**From:** International Window Film Association

**Docket:** 13-CCEJA-1

**RE:** California Energy Commission (CEC) Business Meeting - Agenda Items #5:

From: Energy Analysis for Window Films Applications in New and Existing Homes and Offices  
 Table 8: Residential Retrofits: TDV saved/\$100 spent for Climate Zone 12

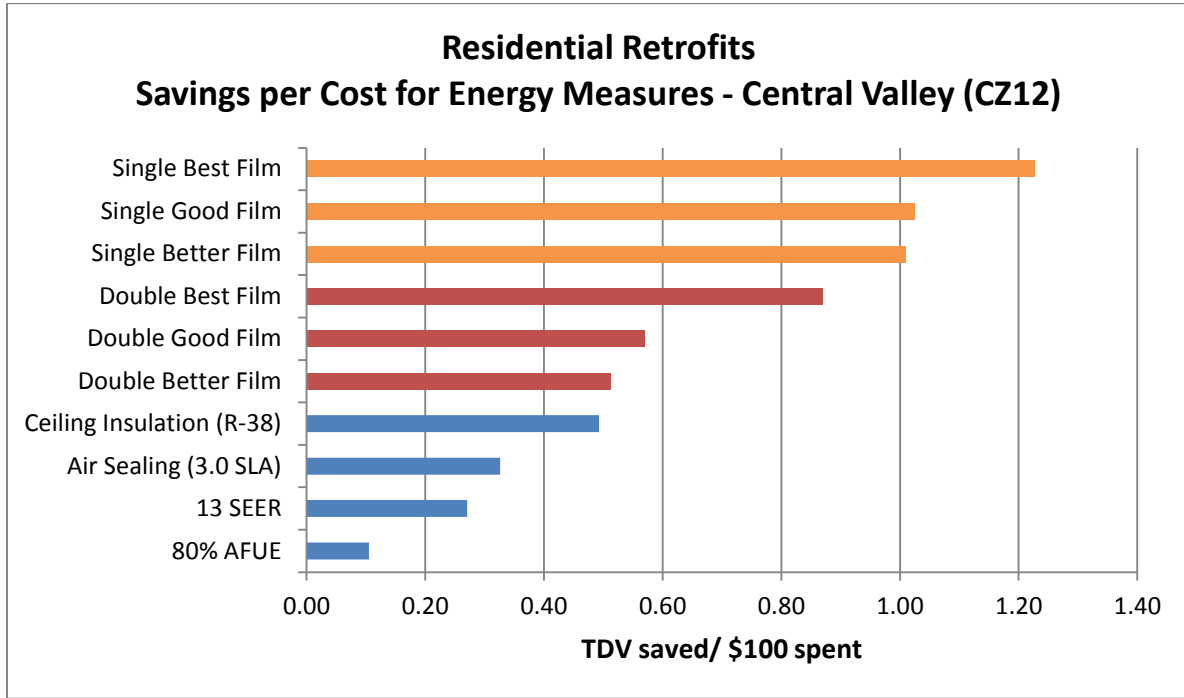
The edit IWFA suggests for Appendix F is to list window film separately with a 15 year Effective Useful Life. The sources for Appendix F are the 2008 and 2011 Databases for Energy Efficiency Resources (DEER). Unfortunately DEER cites window film references from the early 2000s. IWFA is asking DEER in their current revision(s) to update the database to 15 years based on technological improvements as well as warranty and NFRC requirements. The Department of Energy's Weatherization Assistance Program (WAP) requires analysis to determine cost effective improvements to buildings. The WAP software, the National Energy Audit Tool (NEAT), is in the eighth family of revisions. In NEAT v8 and subsequent software versions, window films have been assigned a 15 year EUL (see following tables).

IWFA requests that the Prop. 39 Guidelines, Appendix F, list window film as separate line item with a useful life of 15 years. IWFA also suggests that a footnote be added to require window films to be NRFC certified and have a minimum 10 year warranty.
